**Re: Tampa Electric Company
Polk Power Station
Reclaimed Water Pipeline
Environmental Resource Application
DEP Case No. PA92-32M; OGC Case No. 11-0604
File No. 53-0304847-003
Request for Additional Information**

CONSTRUCTION PLANS
FOR
TAMPA ELECTRIC COMPANY
RECLAIMED WATER PIPELINE

TYPICAL OPEN CUT TRENCH DETAIL - UNPAVED AREAS

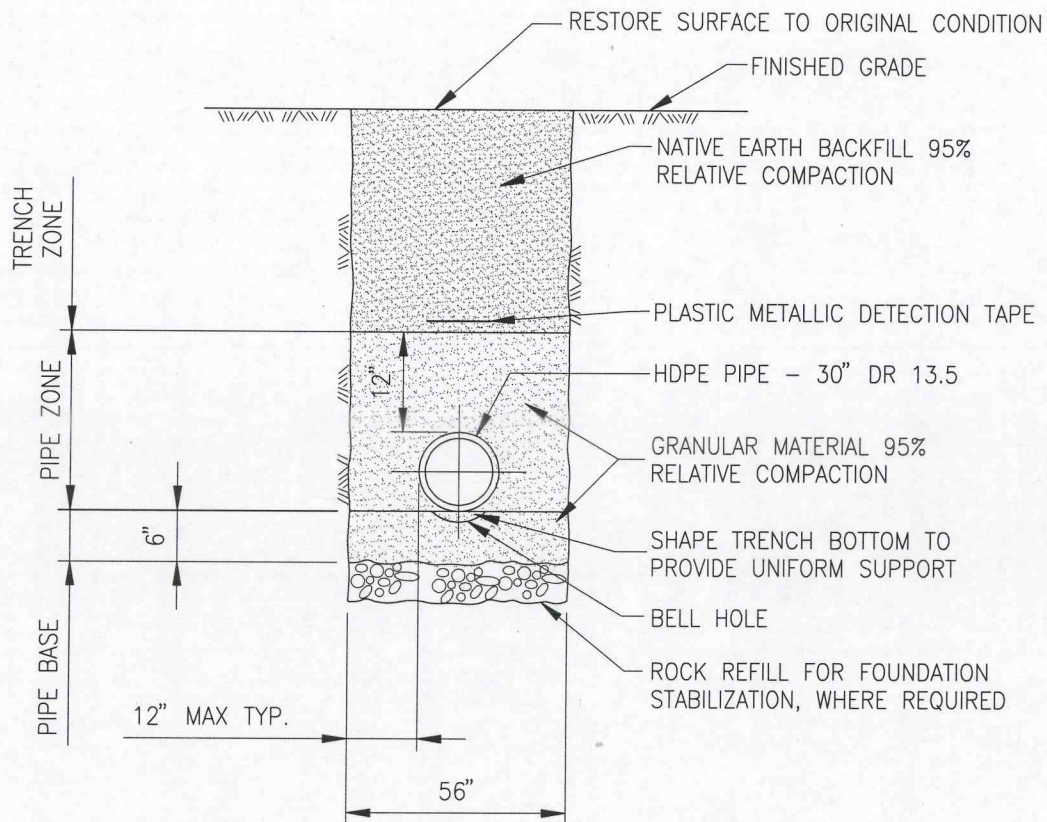
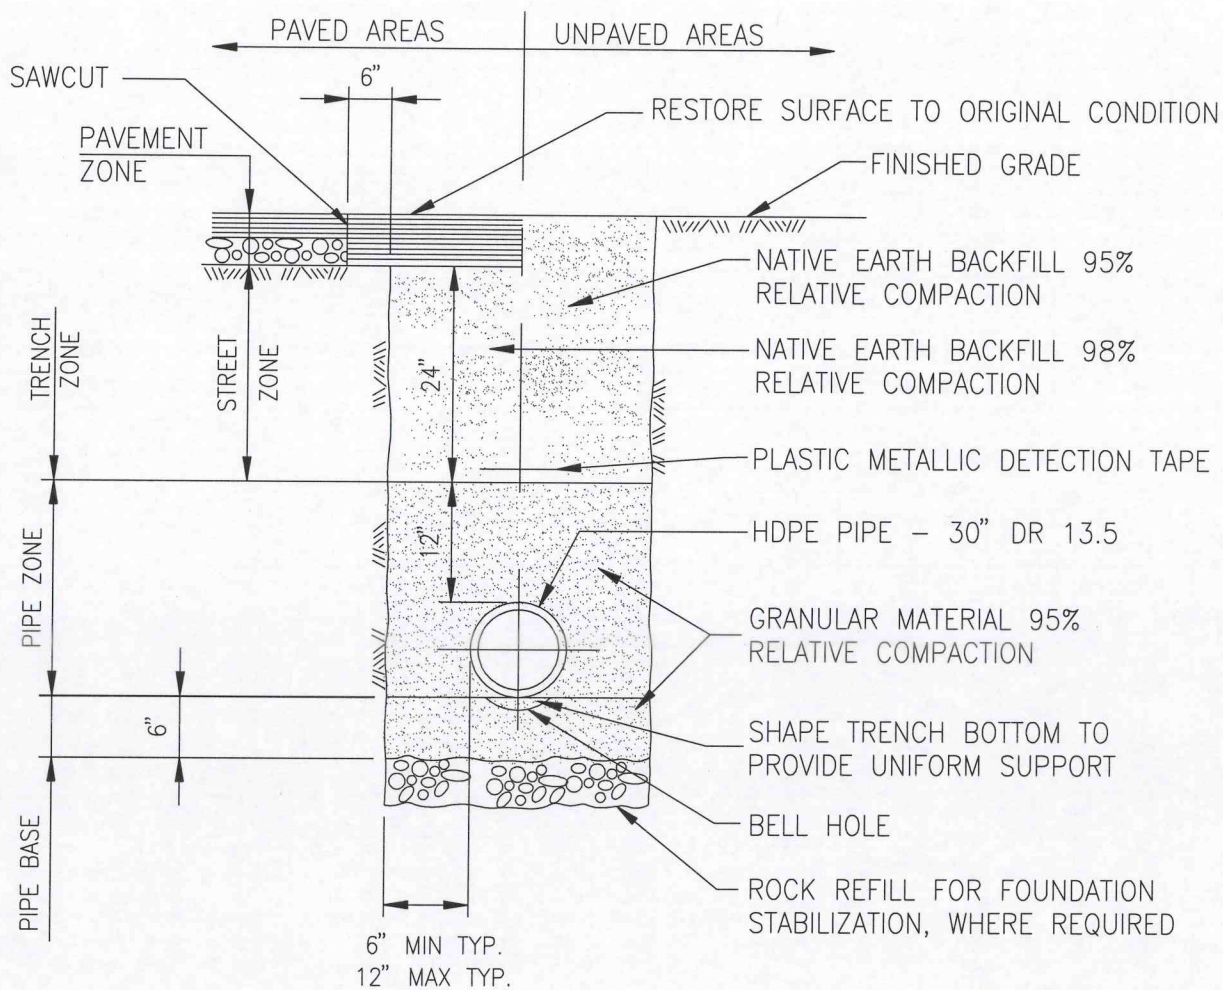
Typical plan-view and cross-section drawings of the proposed open-cut pipeline trenches were not provided with the project drawings. Please provide dimensioned typical plan-view and cross-section drawings of the proposed open cut trenches within the wetland and upland areas. Please also represent the spoil piles and breaches in the drawings. (refer to Chapter 3.1.1, 3.2.1 and 4.8 of the B.O.R.).

Please see Appendix B which contains a typical cross-section drawing of the proposed open cut trenches. Spoil piles will be placed outside of wetland areas, where possible. All grades will be re-established and historical flow patterns returned to pre-construction activities once the project is complete.

FIGURE_196-208.DWG	60218603
FILE NAME	PROJECT NUMBER
TAMPA ELECTRIC COMPANY POLK POWER STATION RECLAIMED WATER PIPELINE PROJECT PLAN VIEW POLK COUNTY, FLORIDA	
ENERGY SUPPLY - GENERATION ENGINEERING	
SHEET 203 OF 221	0

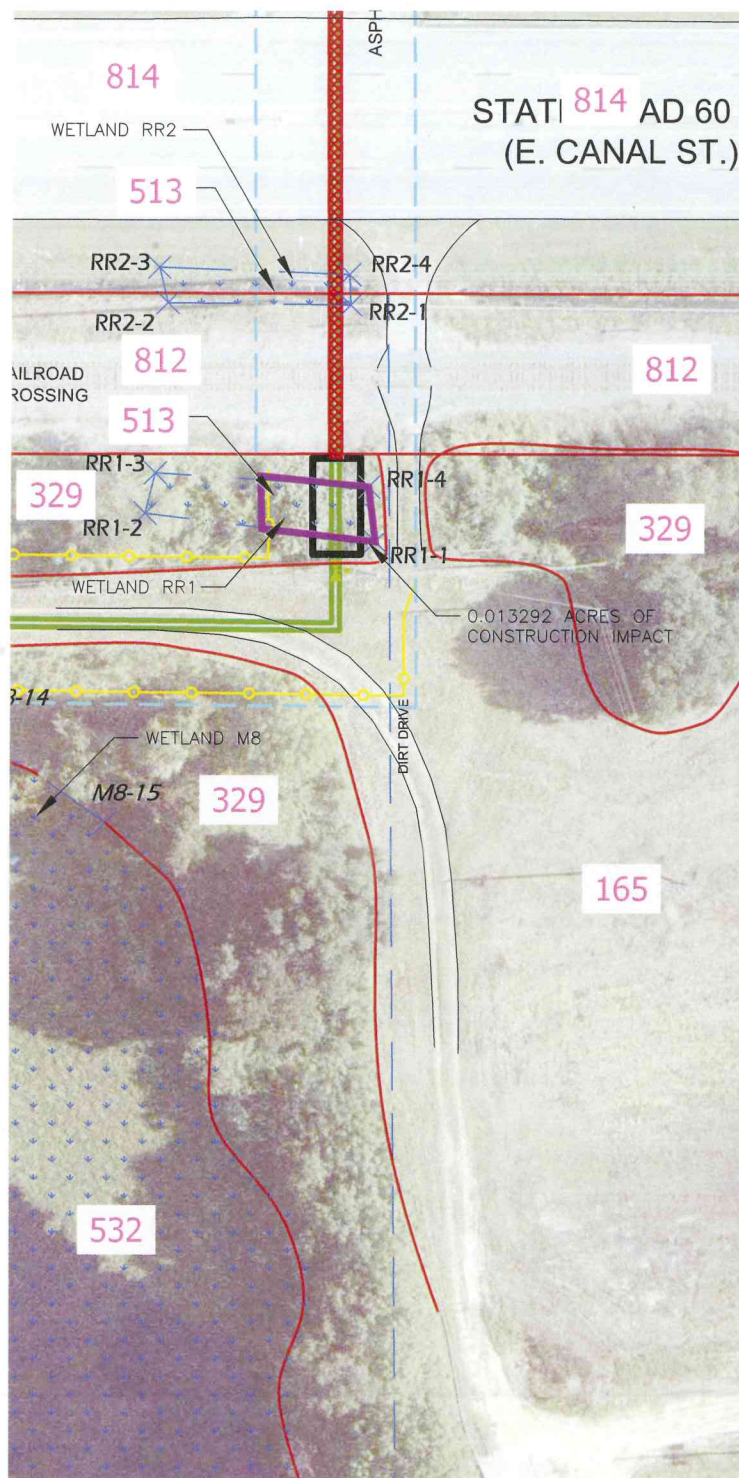
Sheet 203 of the submitted plan-view drawings shows a jack and bore receiving pit on the south side of State Road 60. I site inspection conducted by Department personnel on July 27, 2012 revealed that the location of this receiving pit appears to be located within a ditch system. A ditch system was not identified on the above referenced drawing sheet. Please revise the plan-view drawing to include labeling and impact area to the ditch. Please consider revising the plan-view drawings to relocate the receiving pit to an adjacent upland area pursuant to Section XVIII(C) of the General Conditions of Certification, PA 92-32M).

issues with CSX and the Florida Department of Transportation and 3) scheduling conflicts, to name just a few. The impact acreage for this section of the pipeline is 0.013 acres of upland, cut manmade ditch, FLUCFCS 513. A revised table of wetland impacts is provided in Appendix E. Before, during and after installation of the bore pit in the man-made ditch, TEC will follow all of the Best Management Practices previously described in the ERP application for work in and around wetlands and surface waters (e.g., sediment controls will be utilized to protect downstream systems from siltation and sedimentation). Due to the nature of the impacted wetland no changes are required or proposed to the previously submitted mitigation plan.

SHEET 189 OF 221

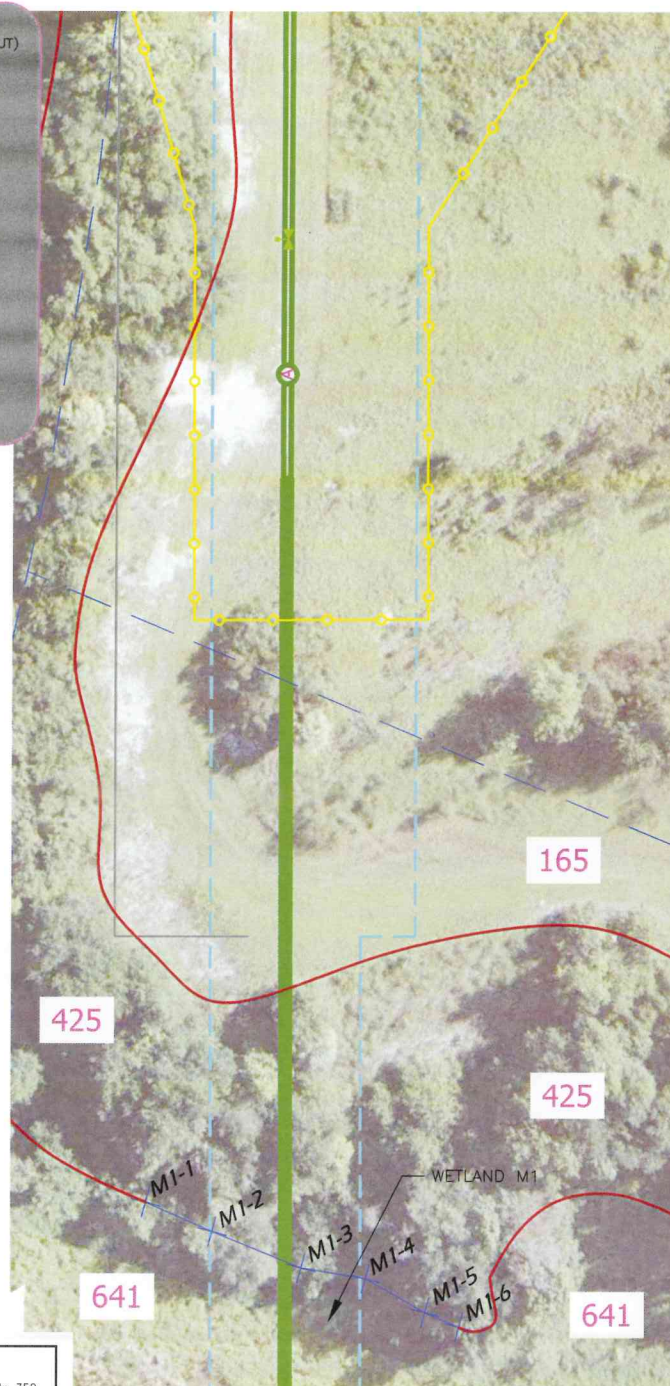
Sheet 189 of the submitted plan-view drawings shows a commencement location for Horizontal Directional Drilling (HDD) on the north side of the north prong of the Alafia River. The drilling commencement location is located outside the area proposed to be contained with Best Management Practices (BMPs). Please revise the plan-view drawing to represent the use of BMPs around the drilling commencement location (refer to Section XXVIII (B) (3) of the General Conditions of Certification, PA-92-32M).

Please see Appendix F which contains a revised Sheet 189 indicating that BMPs will protect the area surrounding the commencement location for the HDD.

FIGURE_94-106.DWG	60218603
FILE NAME	PROJECT NUMBER
TAMPA ELECTRIC COMPANY POLK POWER STATION RECLAIMED WATER PIPELINE PROJECT PLAN VIEW POLK COUNTY, FLORIDA	
ENERGY SUPPLY - GENERATION ENGINEERING	
SHEET 104 OF 221	0

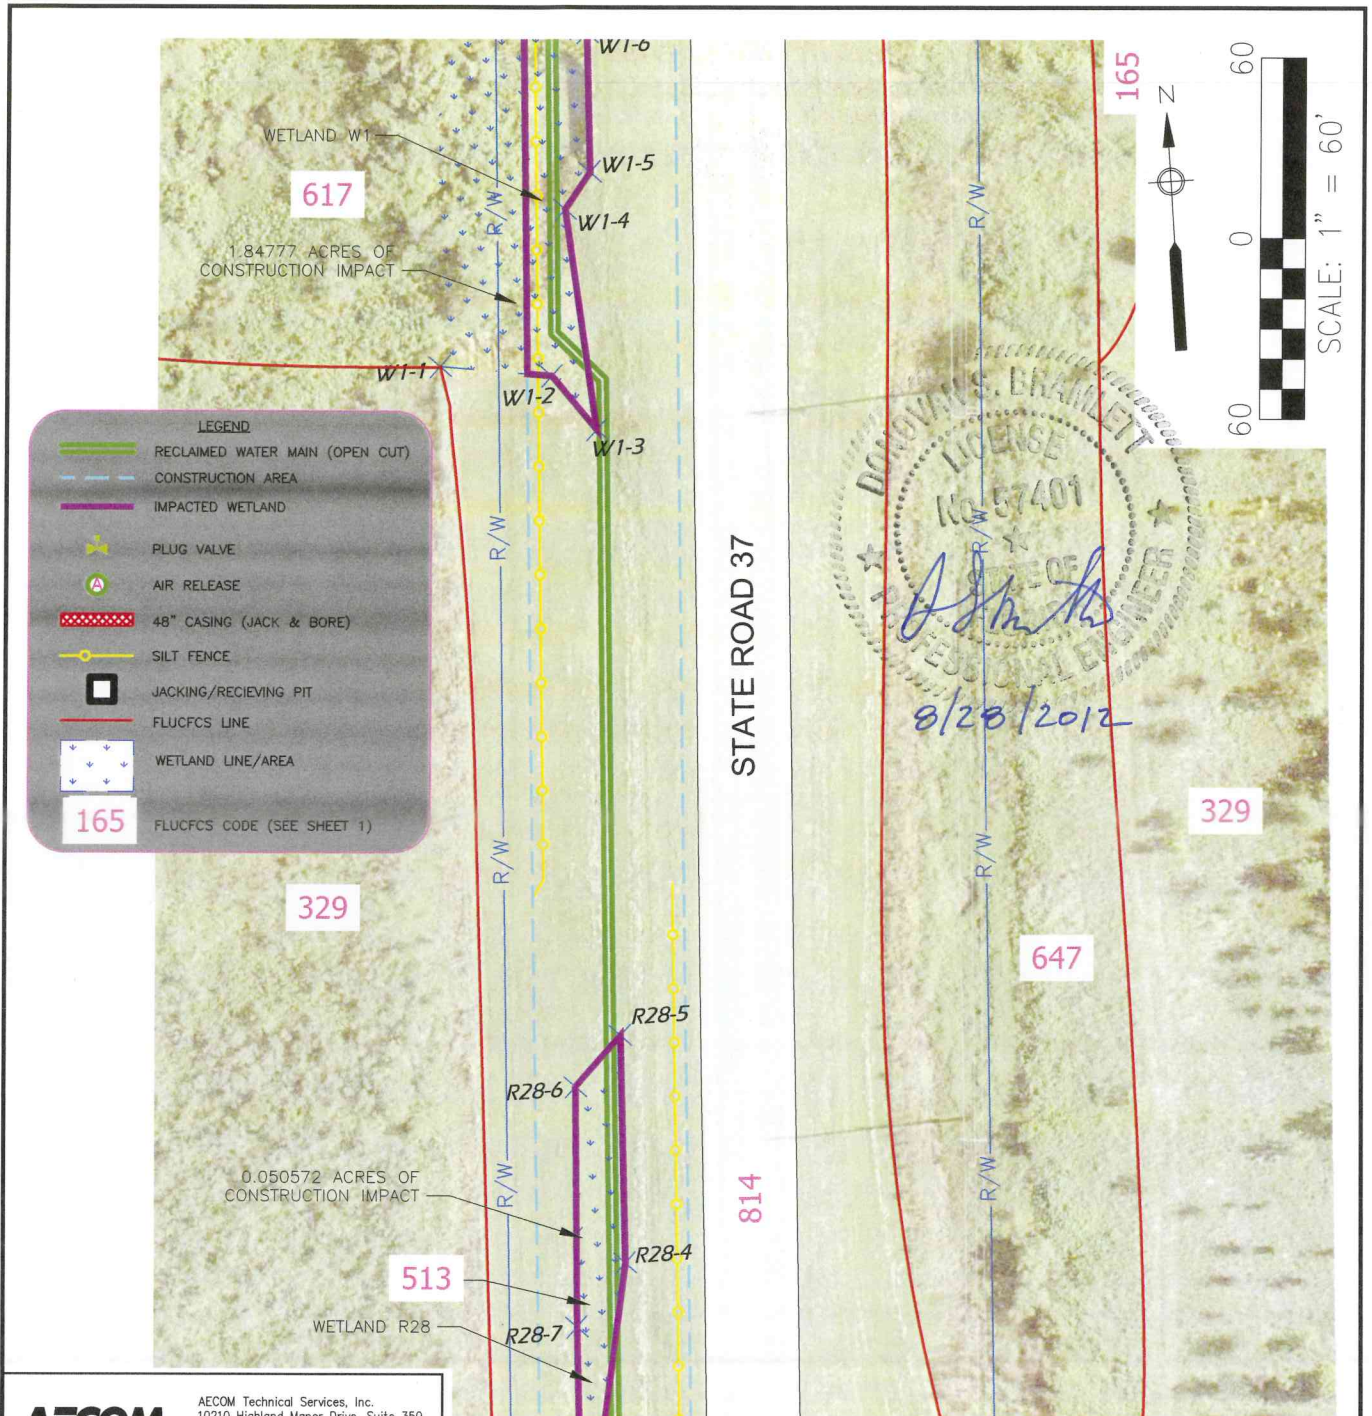
Sheet 107 and 104 of the submitted plan-view drawings shows an additional un-labeled green line just east of the proposed pipeline. Please revise the plan-view drawing to clarify/identify this line by either labeling this line or by removing from the drawing sheet.
